# 802.3dj D1.4

## Comment Resolution

### Electrical Track

Adee Ran (Cisco), 802.3dj Electrical Lead Editor  
Matt Brown (Alphawave), 802.3dj Chief Editor  
Howard Heck (TE connectivity)

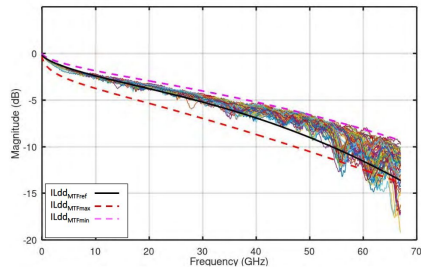
CI 179B SC 179B.4.1 P 808 L 15 # 139

MTF ILdd max and min limit lines are TBD

Insert upper and lower MTF ILdd limit lines in figure 197B-2 and equations 179B-3 & 179B.4 using values presented in contribuion given in March plenary

PROPOSED ACCEPT IN PRINCIPLE.

The comment and the suggested remedy are reasonable, but consensus is not obvious.

Pending review and CRG discussion of the following contribution:

<URL>/sekel\_3dj\_01\_2503

Proposal in [sekel\\_3dj\\_01\\_2503](#)

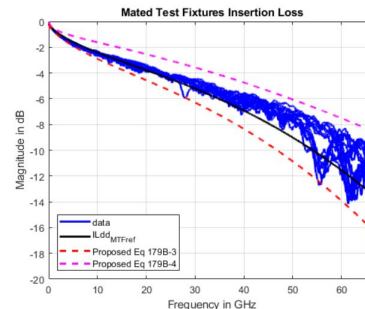
CI 179B SC 179B.4.1 P 808 L 9 # 1

The mated test fixture insertion loss is TBD

Adopt the proposal in

PROPOSED ACCEPT IN PRINCIPLE.

Resolve using response to comment #139.

Prior proposal in [kocsis\\_3dj\\_adhoc\\_01\\_250206](#)

Editor's recommendation: adopt the more recent proposal sekel\_01, referenced in #139.
